simpsonhaugh

First Street South - Manchester

10266-SHP-RP-PA-012 | Planning Amendment NMA 04 | November 2022

Level 41-42 Reduced Apartment Numbers
(5 Apartments - 13 Beds)

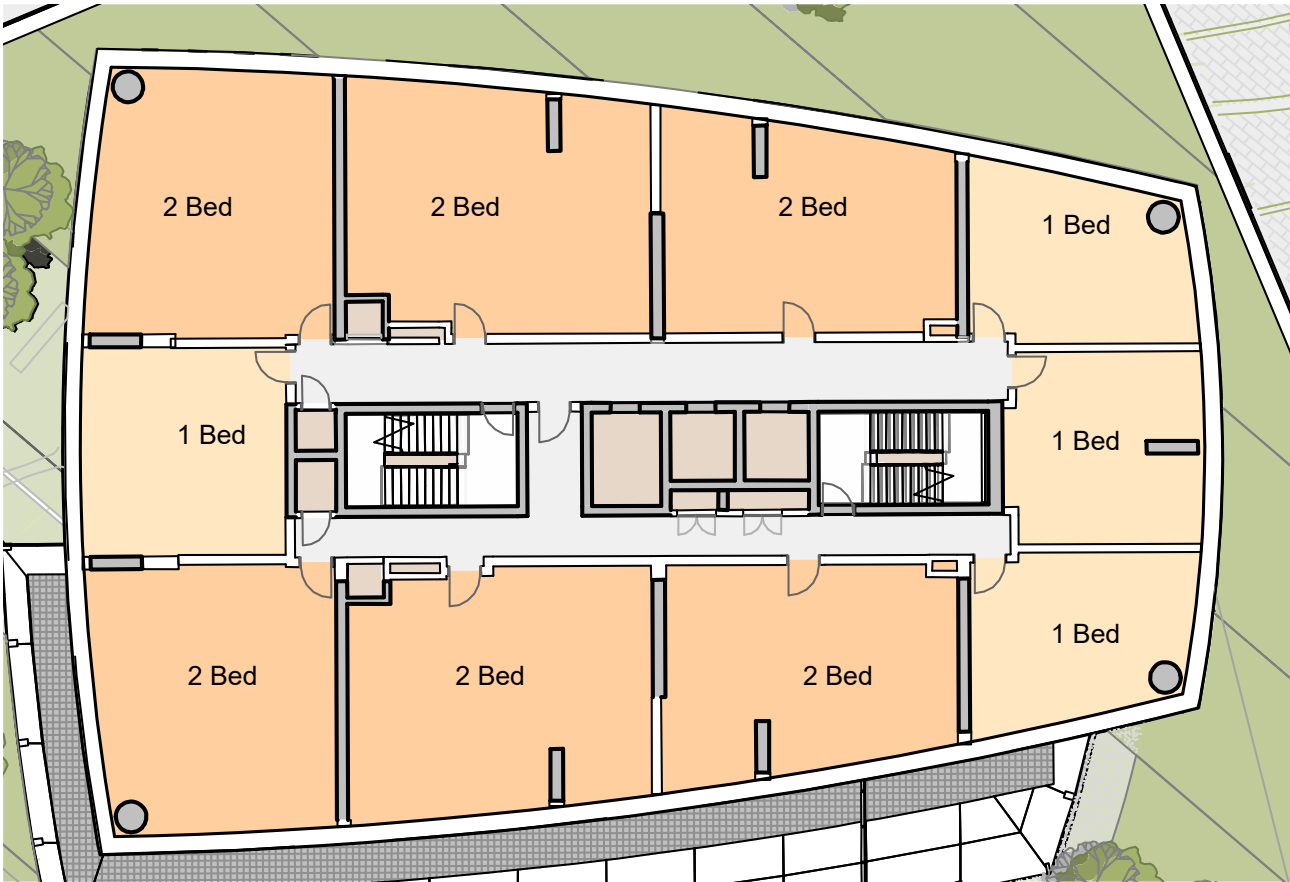
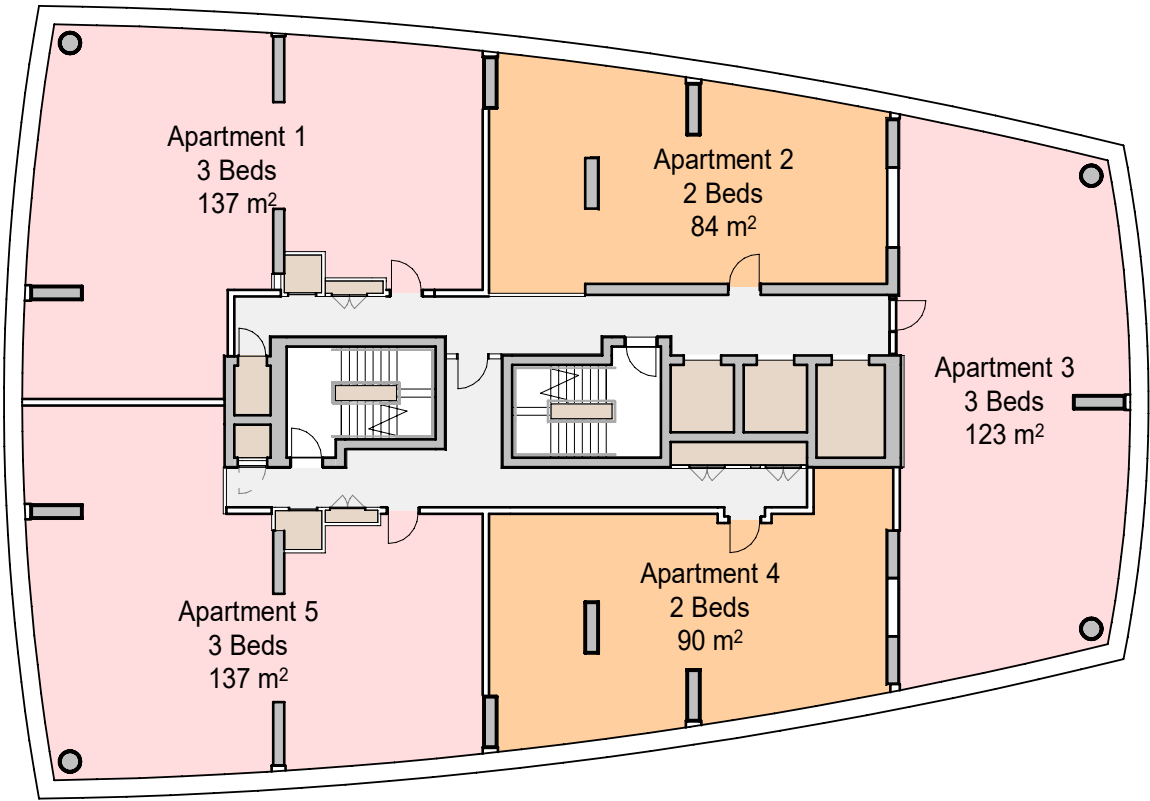
1. Level 41-42 Reduced Apartment Numbers
(5 Apartments - 13 Beds)

- 1. Typical floor are to be redesigned to improve on the range of apartment types available within the development.

Amendments:
Building D - Alternative apartment Types

Typical floor plan on the upper most levels are to be redesigned to improve on the range of apartment types available within the development. The full extent of the change is still in discussion with the client but it is the intention to provide a number of apartments that are larger than NDSS. The overall apartment and bedroom provision will not be greater than the approved scheme.

Level 43-44 Reduced Apartment Numbers
(4 Apartments - 12 Beds)

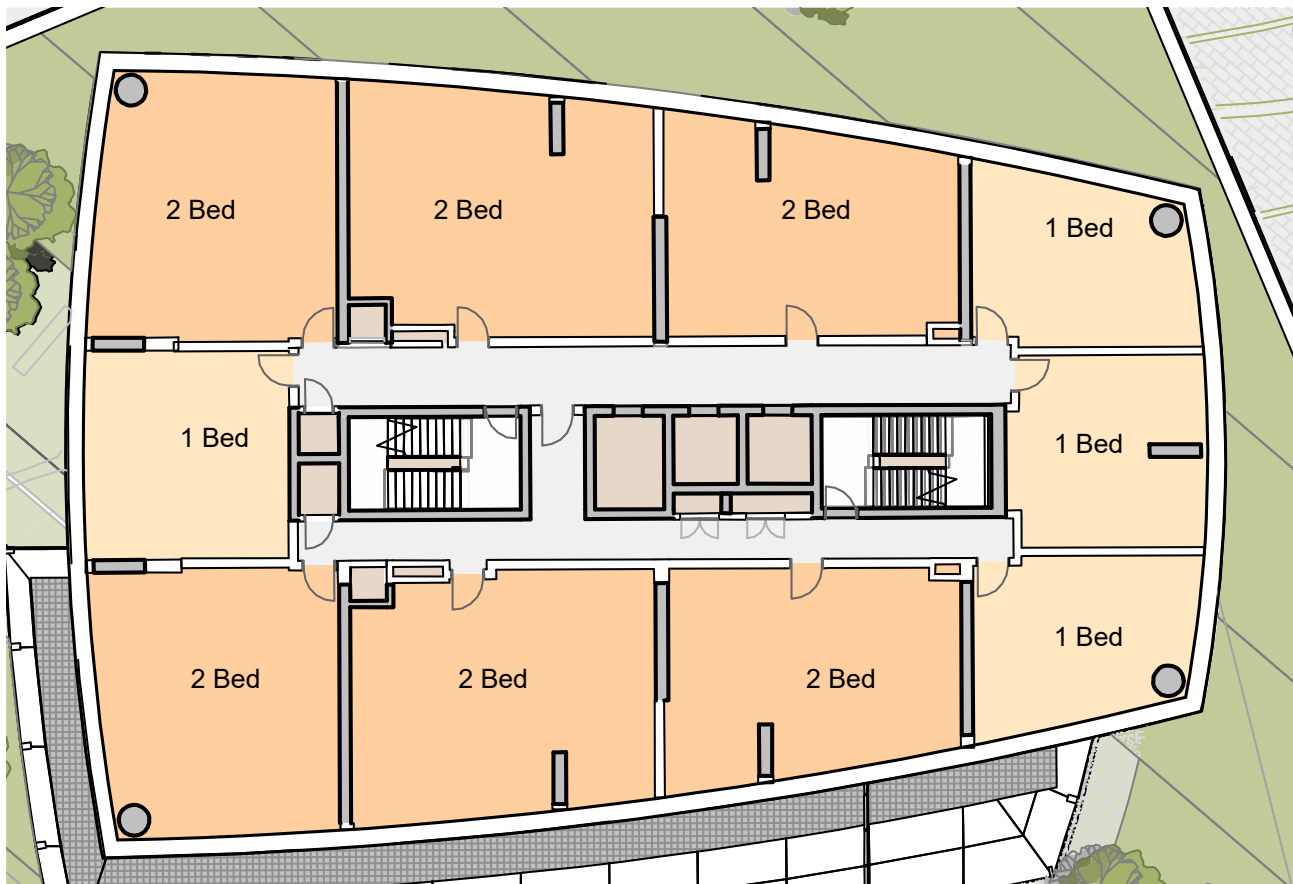
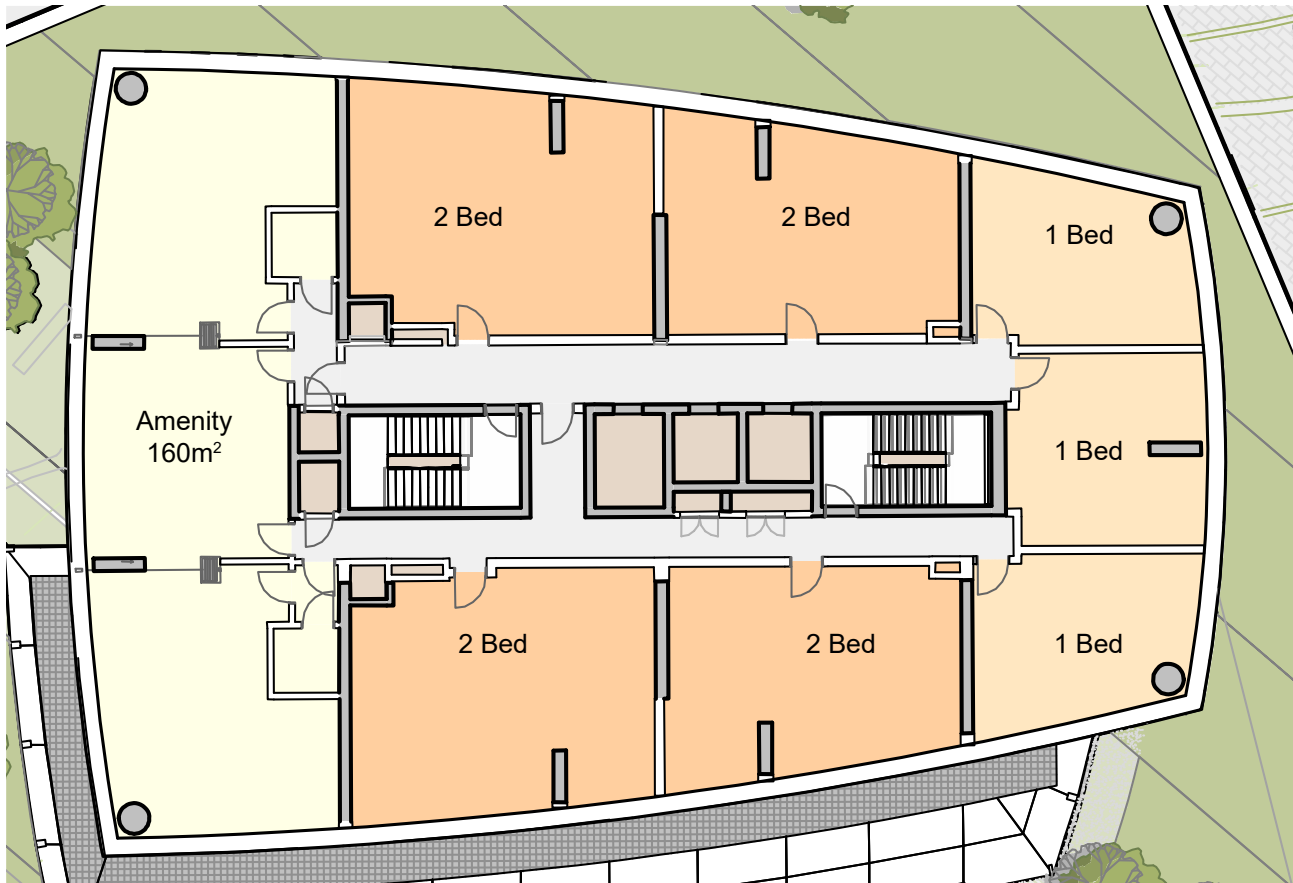
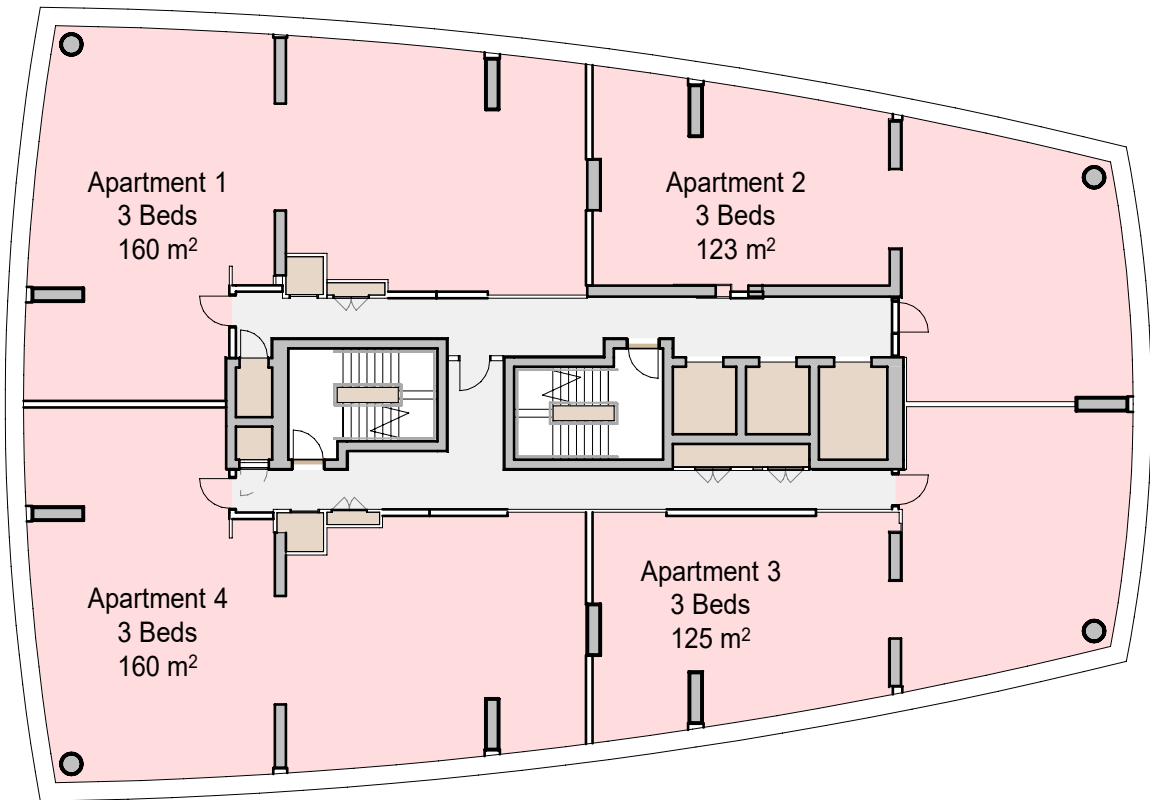
1. Level 43-44 Reduced Apartment Numbers
(4 Apartments - 12 Beds)

Amendments:
Typical floor plan on the upper most levels are to be redesigned to improve on the range of apartment types available within the development. The full extent of the change is still in discussion with the client but it is the intention to provide a number of apartments that are larger than NDSS. The overall apartment and bedroom provision will not be greater than the approved scheme.

Amendments:
Building D - Alternative apartment Types

Typical floor plan on the upper most levels are to be redesigned to improve on the range of apartment types available within the development. The full extent of the change is still in discussion with the client but it is the intention to provide a number of apartments that are larger than NDSS. The overall apartment and bedroom provision will not be greater than the approved scheme.

Level 44 - Relocate Amenity Space

Based on the client's experience of how amenity spaces are used in their other schemes, they have determined that separating the amenity space between levels will not be as successful as concentrating all the amenity within close proximity of one another.

With this in mind, amendments to the ground floor level have been made to increase the provision at ground as well as reconfiguring the first floor amenity functions, creating a focal point for the amenity and make up for relocating the amenity currently provided on level 44.
